SERVICE BULLETIN

SB1246

ADDRESSEES	: Owners and operators of coaches listed under 'Application'
VEHICLE MODEL	: C2045, T2140, T2145
SYSTEM/SUBSYSTEM	: Electrical system
BULLETIN TYPE	: Safety Recall NHTSA 12V-495/ TC 2012-344
DATE	: November 12, 2012
SUBJECT	: Alternators mounted on Detroit Diesel engine – To add ground cables
TERMS & CONDITIONS	: Refer to the warranty section further in this Bulletin.

Figure 1: Alternator ground cables

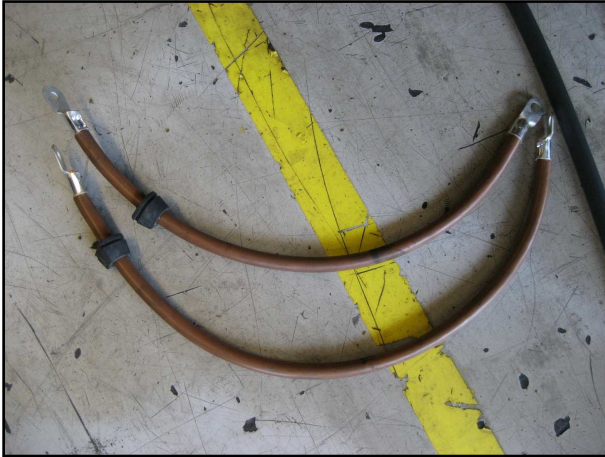
1. Van Hool NV has decided that a defect which relates to motor vehicle safety exists in the above-mentioned coaches, equipped with a Detroit Diesel DD13 engine without ground cables installed on the Prestolite AC172 alternators.
2. The alternator might fail due to excessive heat caused by a progression of the inter-surface corrosion of the electric path of the minus diode plates. The alternator components may melt, possible resulting in smoke and creating a risk for a potential fire hazard.
3. The remedy is to fit a ground cable to both alternators mounted on the engine. For this purpose, ground cables have been made available. Refer to the procedure in this Service bulletin for fitting instructions. The terms and conditions of the campaign have been detailed in the warranty section.

VH reference	Description	Qty.
11271513	Set of two ground cables (with grommets)	1
660224301	Screw	1
660627920	Washer	1

Figure 3

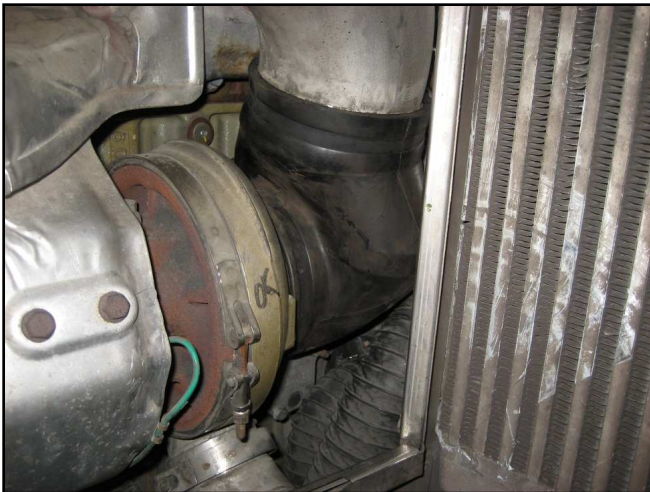
- 3) Remove the rubber hose at the turbocharger (Figure 3).

Figure 4

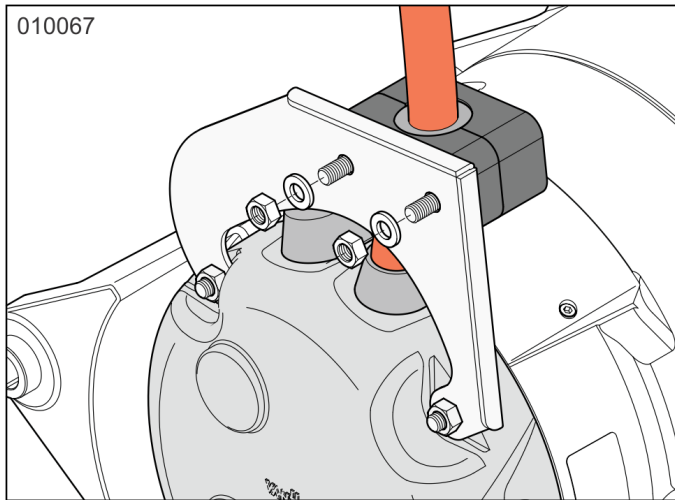
- 4) Remove the air hose connected to the protective cover of both alternators.
- 5) At the upper alternator only: remove the nuts securing the positive cable clamp to the cable support (Figure 4).

Figure 5

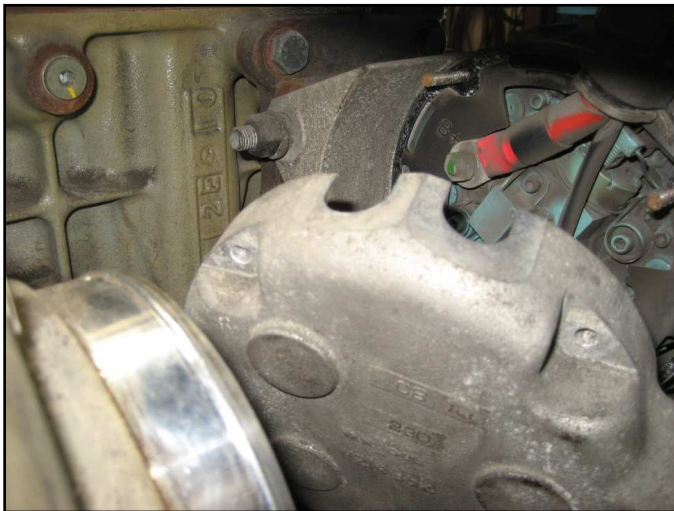
- 6) At the upper alternator only: remove the cable support.
- 7) Re-install the nuts to prevent cable clamp falling to pieces.
- 8) Remove the protective cover of both alternators (Figure 5 shows protective cover of upper alternator).

Figure 6

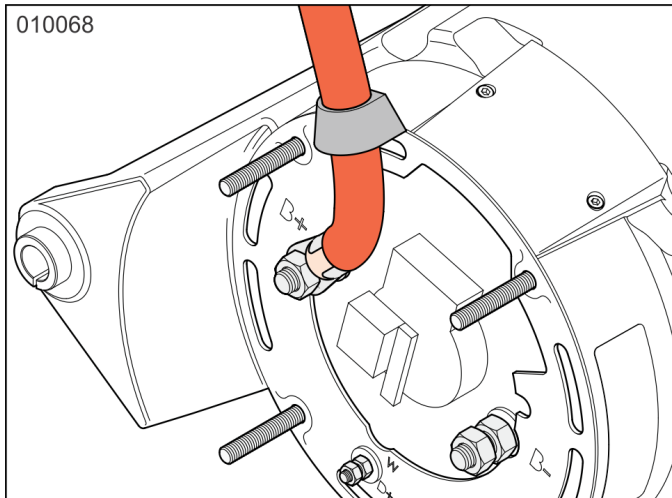
- 9) Slacken the terminal nut of the red positive cables. Re-route the positive cables so that they will pass afterwards through the left hole of the protective cover. Re-tighten the terminal nut of the positive cables to a torque of 6.6 to 9.6 ft.lbf (9 to 13 Nm) (Figure 6 shows upper alternator).

Figure 7

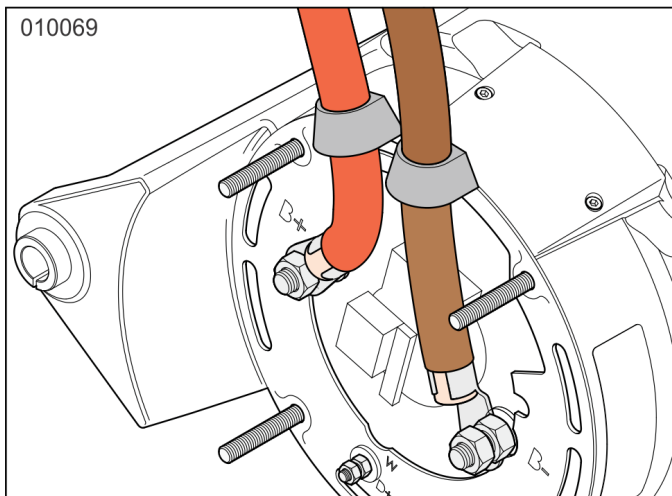
- 10) Install the ground cables on both alternators. Route the ground cables so that they will pass afterwards through the right hole of the protective cover. Re-tighten the terminal nut of the ground cables to a torque of 6.6 to 9.6 ft.lbf (9 to 13 Nm) (Figure 7 shows upper alternator).

Figure 8

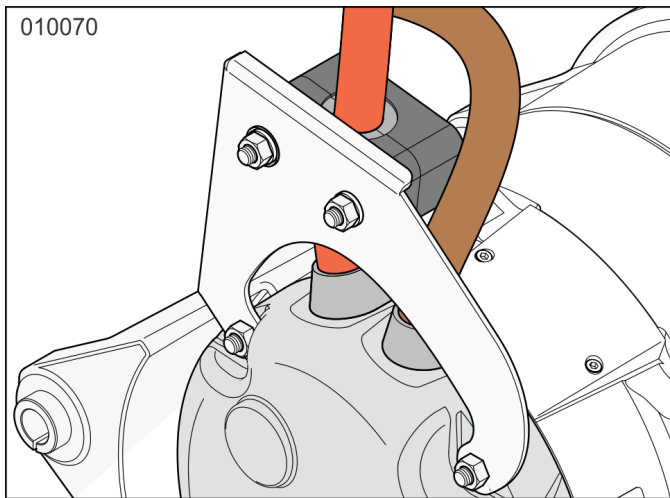
- 12) Install the protective cover of the upper alternator. Verify that the rubber grommets for the cables are in place. Install the positive cable support in reverse of original position and secure the cable clamp to the support. Secure the protective cover (Figure 8).

Figure 9

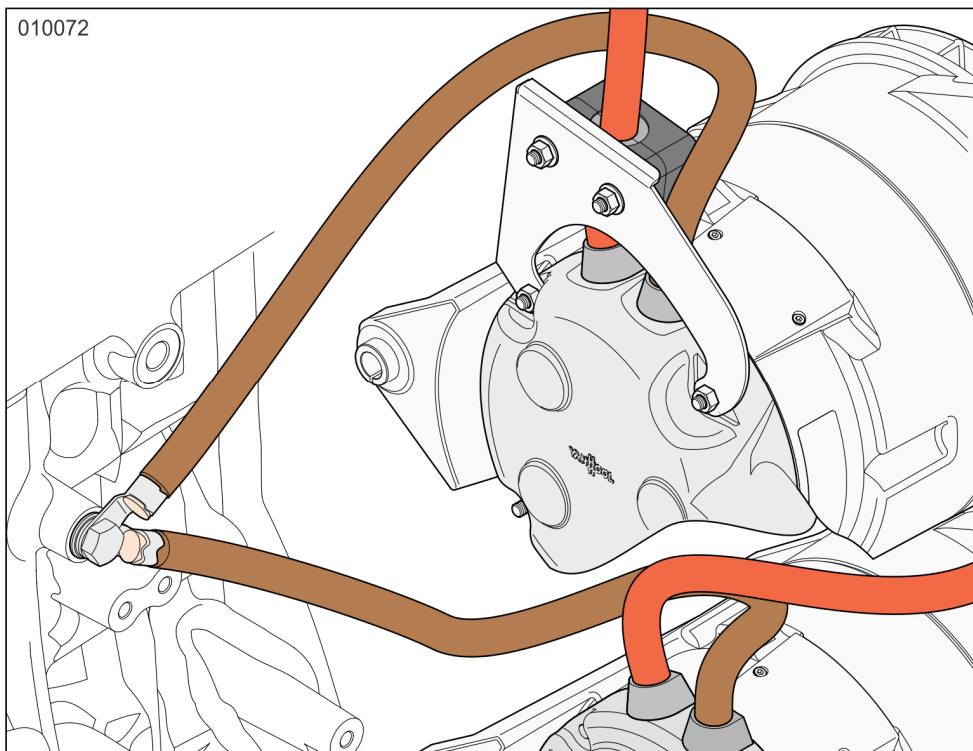
- 13) Reconnect the air hose at the rear of both alternators.
- 14) Secure the ground cable of both alternators to the engine block. Tightening torque of screw: 16 ft.lbf (21 Nm) (Figure 9).
